# Access Compliance Report

## Public Rights-of-Way

### (Pedestrian Signals)

Intersection ID: N/A	Main Street:	Cross Street: N/A	Location: N/A
ADA ID: 1F0E6AB3A965	Signal Type: One Push Button-Non APS	Overall Compliance: No	Severity Score: BTN 1: N/A BTN 2: N/A No BTN: N/A
Codes/Mitigation Info/Possible Solution		Field Measurements/Component Compliance

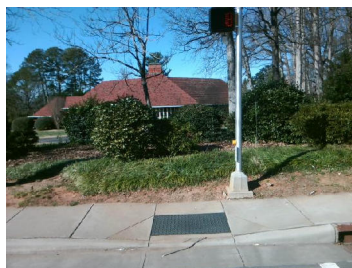
PROW/ADA: R404.2, R404.3

N/A	B 1 FWD Approach Width (in)	N/A	N/A	B 2 FWD Approach Width (in)	N/A
N/A	B 1 FWD Approach Obstruction?	N/A	N/A	B 2 FWD Approach Obstruction?	N/A
N/A	B 1 FWD Approach Obstruction Dist (in)	N/A	N/A	B 2 FWD Approach ObstructionDist (in)	N/A
N/A	B 1 PARA Approach?	Yes	N/A	B 2 PARA Approach?	N/A
N/A	B 1 PARA Approach Constrained?	No	N/A	B 2 PARA Approach Constrained?	N/A
Yes	B 1 PARA Approach Reach (in)	9.0	N/A	B 2 PARA Approach Reach (in)	N/A
N/A	B 1 PARA Approach Width (in)	N/A	N/A	B 2 PARA Approach Width (in)	N/A
N/A	B 1 PARA Approach Obstruction?	Yes	N/A	B 2 PARA Approach Obstruction?	N/A
N/A	B 1 PARA Approach Obstruction Dist (in)	3.0	N/A	B 2 PARA Approach ObstructionDist (in)	N/A
No	B 1 Clear Floor Space Slope (%)	4.2	N/A	B 2 Clear Floor Space Slope (%)	N/A
No	B 1 Clear Floor Space XSlope (%)	7.9	N/A	B 2 Clear Floor Space XSlope (%)	N/A
N/A	B 1 PAR Slope (%)	4.1	N/A	B 2 PAR Slope (%)	N/A
Yes	B 1 Height (in)	42.0	N/A	B 2 Height (in)	N/A

Possible Solutions: Remove and Replace Clear Space.
